November 7, 1997

**RE: REQUEST TO MODIFY NEW ASPHALT CONCRETE PAVEMENT
PERFORMANCE STANDARD - HARBOR ISLAND S&GOU SUPERFUND SITE**

**Figure 1 Permeability Data for WSDOT Class B Asphaltic Concrete
Harbor Island S&G OU Superfund Site Design Set 1B**

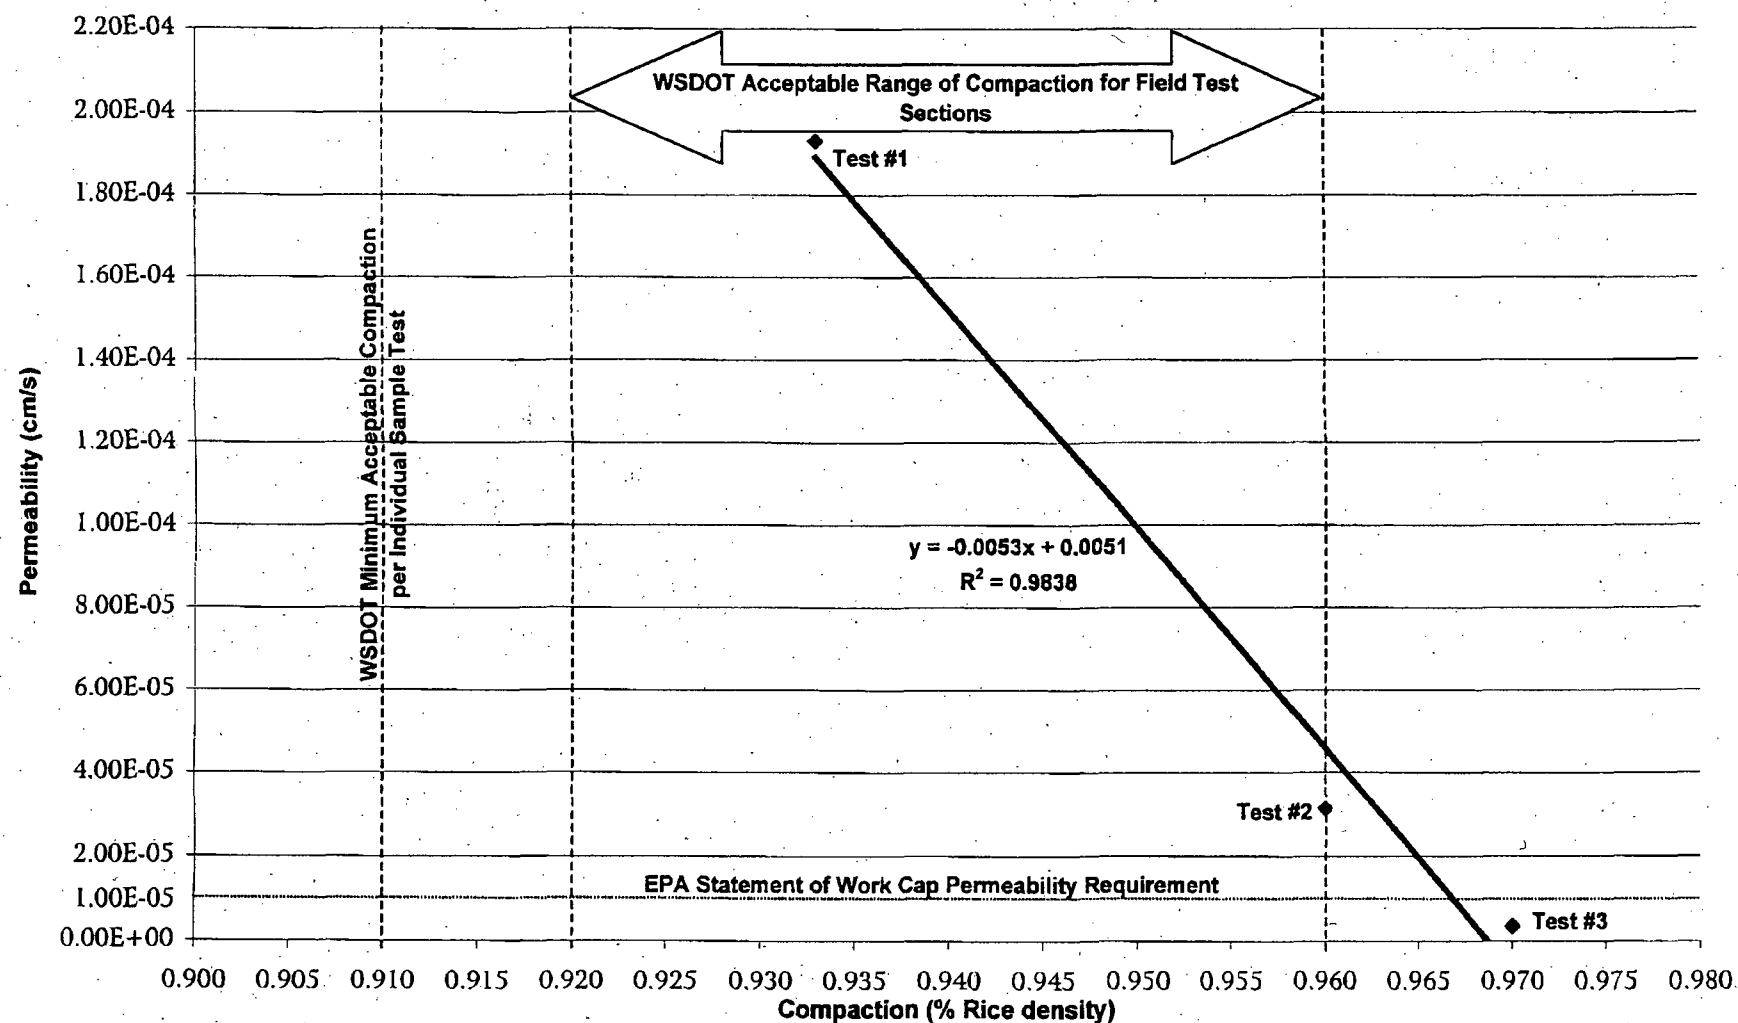
versus compaction for the WSDOT Class B ACP samples recently tested. As illustrated in Figure 1, all lab test samples met the minimum WSDOT compaction of 91 percent. The only sample that met the EPA permeability requirement of 10^{-5} cm/s was Sample #3, which was compacted to a relatively high level of 97 percent. Based on this data, a minimum compaction of 96.7 percent Rice density is necessary to meet the EPA permeability goal.

Based upon both the laboratory testing and subsequent field compaction testing at the UPRR site, it appears that readily available standard asphalt constructed to WSDOT specifications cannot achieve the EPA cap permeability requirement of 10^{-5} cm/s. As there are numerous other sites yet to be paved during remedial actions at the S&GOU, RETEC is requesting that EPA modify the performance standard for new ACP from a permeability criteria of 10^{-5} cm/s to a WSDOT compaction criteria of a minimum 91 percent to a maximum 96 percent Rice density. The bases for this request are listed below:
